Subject: Written Submission: Letter of objection Mod2022/0732(Related

Application: New DA2022/033);30A Addison Rd Manly

RE: Mod2022/0734 (Related Applications: New DA2022/0033); 30A Addison Rd Manly

WRITTEN SUBMISSION: LETTER OF OBJECTION

Drawing 1.

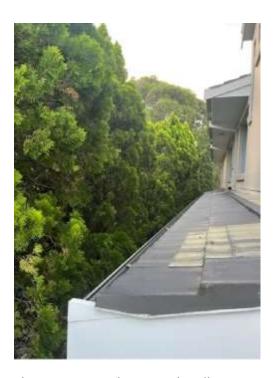
We are practical people and perhaps if it is determined truly that the size of the machinery that needs to get access to 30A Addison Road in order for the approved works to take place that some of the Group G1 trees need to be removed, that there is a commitment from the applicant that they will upon completion replace the removed trees like for like in size, scale and likeness within a prompt period. We do not want to wait 20 years for saplings to grow. The original DA2022/0033 talks of Agapanthus being planted which would be a woeful comparison to the existing Group G1 trees. Agapanthus is a plant, Thuja orientalis are trees. Drawing 1 below attempts to show a scale drawing of the existing trees and proposed replacement plants.
